Categorical Exclusion Documentation Form (CE Form)

Project: Polychrome Area Improvements: Design Changes

PEPC Project Number: 113088

Figure 1 (NPS): Aerial view of Pretty Rocks project area with design change locations.

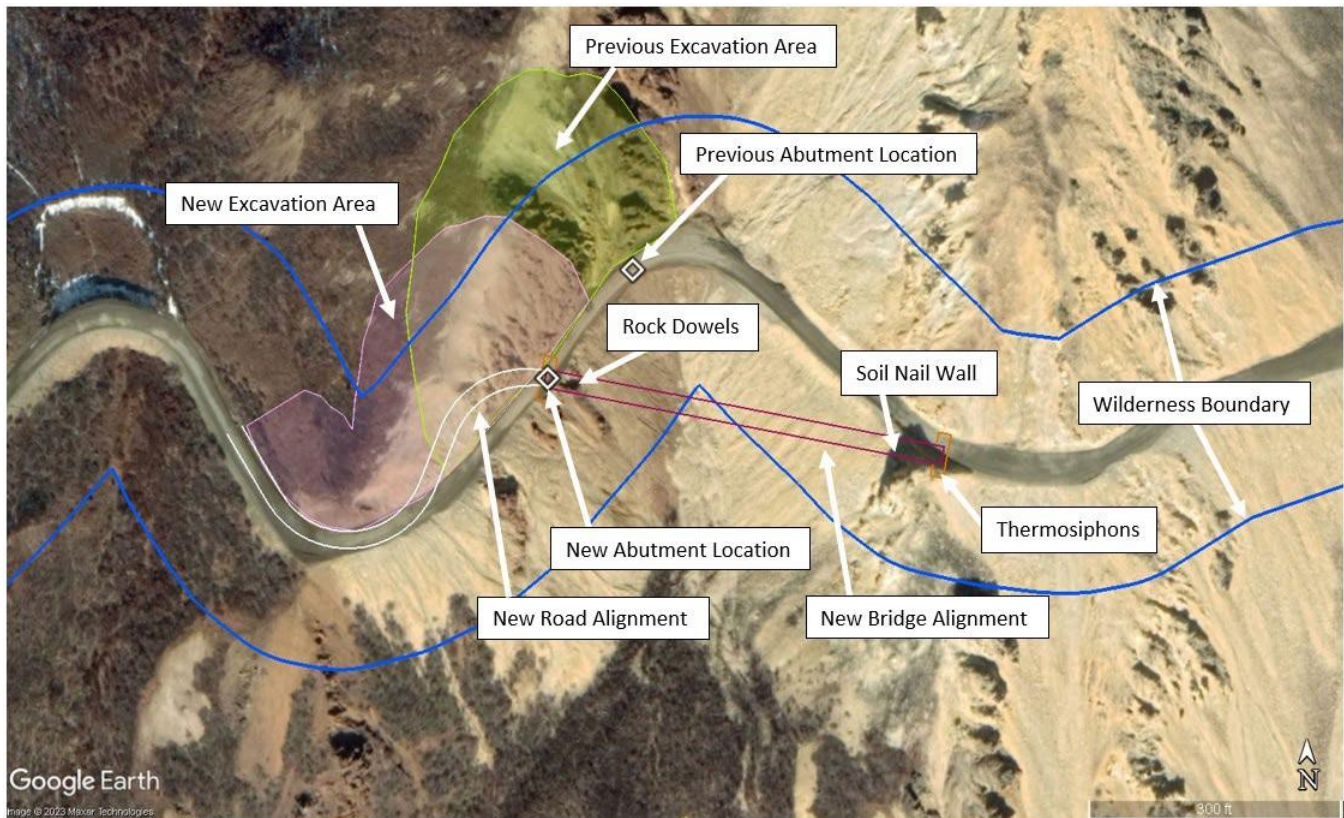
- 1) The western bridge abutment will be constructed approximately 150' to the southwest of the location identified in the EA due to the increased stability of the new location. As a result, the bridge alignment will shift from being suspended above the non-wilderness corridor along the Park Road to being partly suspended above wilderness.

- 2) The new western abutment location will cause the new road alignment on the west side of the bridge to also be repositioned, requiring less excavation in wilderness and less total excavation. The EA estimated 125,000-150,000 cubic yards of total excavation (less than 1 acre in wilderness) and the design changes will result in an estimated 75,000-100,000 cubic yards of total excavation (less than 0.5 acre in wilderness). Correspondingly, there will be less excavated material placed on the slope below the road, including less in wilderness and none in wetlands.

- 3) The excavated slope on the west side of the bridge will no longer include a bench cut, which eliminates the annual maintenance using motorized vehicles in wilderness that was described in the EA. The excavation will still produce rough, irregular rock faces that resemble the surrounding natural rock.

- 4) The new abutment location will require the bridge to be longer and therefore taller: approximately 475 ft long and 50 ft tall compared to the approximately 400 ft long and 10 ft tall bridge represented in the EA. The bridge will still be constructed using weathering steel that is a nonreflective orange-brown color that will darken over time to reduce contrast with the surroundings.

- 5) The design will include the addition of 23 thermosiphons installed in the ground around the eastern abutment of the bridge to mitigate the potential for permafrost thaw and ensure the longevity of the bridge. The EA mentioned that the use of thermosiphons would be researched and evaluated for future design consideration (p.16) and thermal modeling completed since the FONSI resulted in their recommended addition. The thermosiphon condensers will be three-inch diameter cream-colored pipes extending 18 ft above ground and grouped in two racks on the outboard side of the bridge. They will be located as close to the bridge structure as practical, to minimize their visibility.

- 6) The design will include additional measures to stabilize the slopes in front of the abutments: on the east side, a soil nail wall will be installed with a steel wire mesh facing (over an area approximately 25-35 ft tall and 70-80 ft wide) and on the west side, rock dowels will be installed into the slope (over an area approximately 80-90 ft tall and 55-65 ft wide). The project description in the EA included two retaining walls and rock bolts or dowels above the road, while these new installations will be below the road, but they will be outside of wilderness. They will still be designed to match natural surroundings by using weathering steel for the wire mesh and soil nail spike plates and cutting the rock dowels flush with the rock and grouting over them.

- 7) The bridge design will no longer include nest deterrents. The EA included this measure as a possible way to mitigate the impact of human-enhanced raven populations and resulting increased predation on other avian species due to the presence of artificial nesting platforms such as a bridge. It was later determined that nest deterrents such as spikes, netting, lasers, or structure modifications are detrimental to visual resources, a potential hazard for other wildlife, and impractical. Furthermore, there's no evidence that these deterrents would be effective or long-lasting.

- 8) The road near Bear Cave Landslide (MP 44.8) will be temporarily widened as part of Phase I, instead of phase II, to allow for oversize vehicles to turnaround during the bridge construction. The road widening will not occur in wilderness and ground disturbance in the vicinity of known archeology sites will be monitored by cultural resources staff. The road will still be returned to the existing roadway centerline and width, and the disturbed area will still be revegetated following the completion of the Polychrome Area Improvements.

Figure 3 (Jacobs): The reduced material placement area will avoid the 0.59 acres of wetlands located outside zones 1-3.

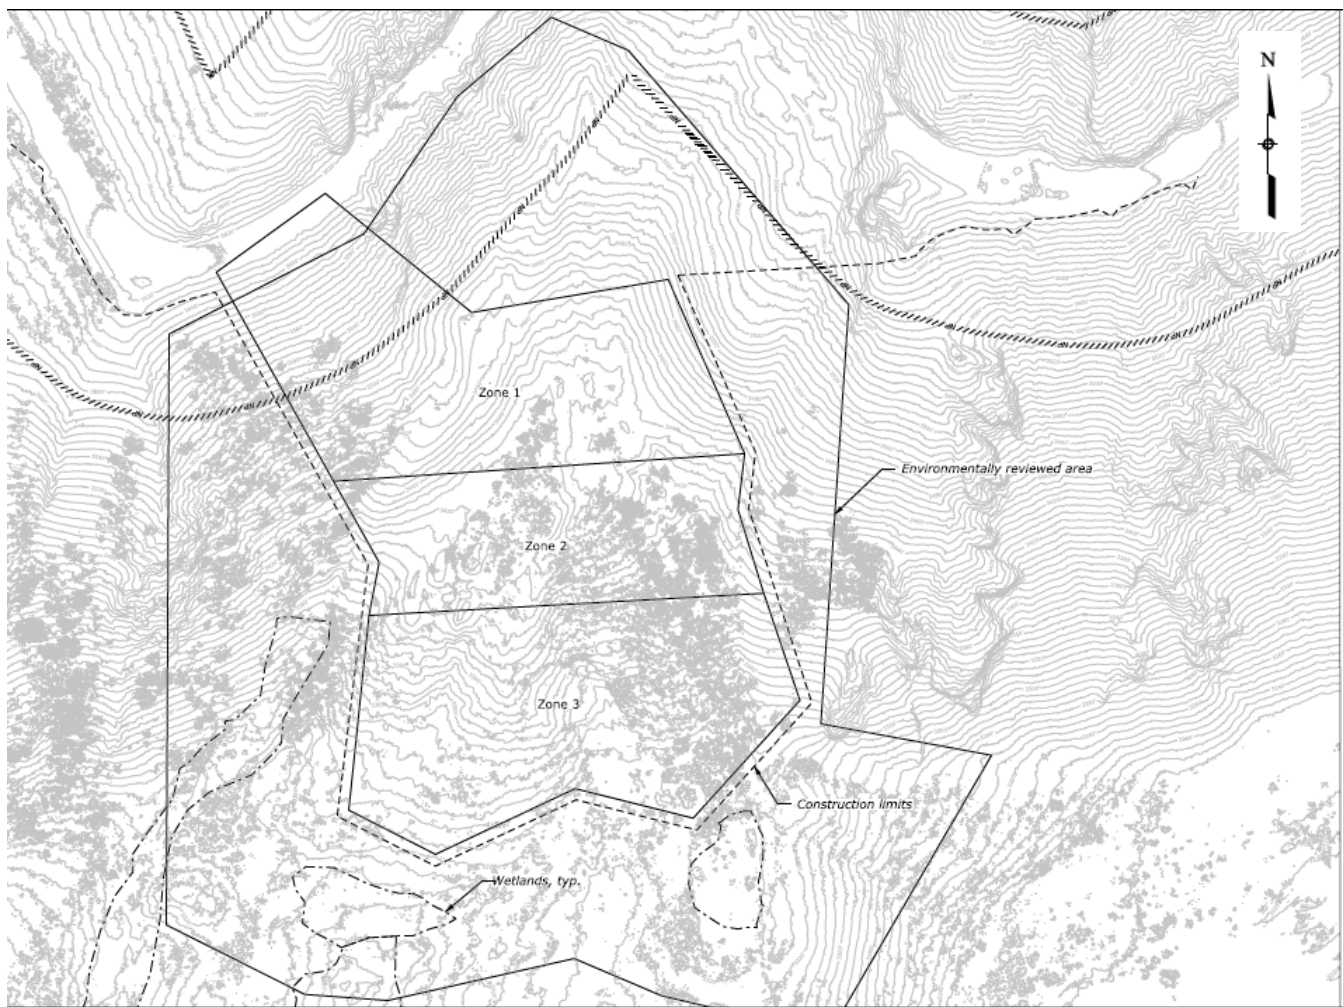
Additional impacts: Although more than 0.5 acres of vegetation may be permanently lost from the road corridor around Bear Cave Landslide, the reduction in the amount of excavation and material placement in the area around the Pretty Rocks Landslide will retain more of the vegetated slope above the road on the west side of the bridge and will bury less of the vegetated slope below the road, which will lessen the overall loss of vegetation from the project. Less excavation will also reduce the material placement area on the slope below the road, thereby avoiding the direct disturbance of 0.59 acres of wetlands on the toe of the landslide (Figure 3). The change in the timing of the temporary road widening at Bear Cave will result in clearing roadside vegetation a few years sooner than originally planned. will not cause additional impact to the vegetation or the park's ecosystem. The area will still be revegetated following the completion of the Polychrome Area Improvements project.
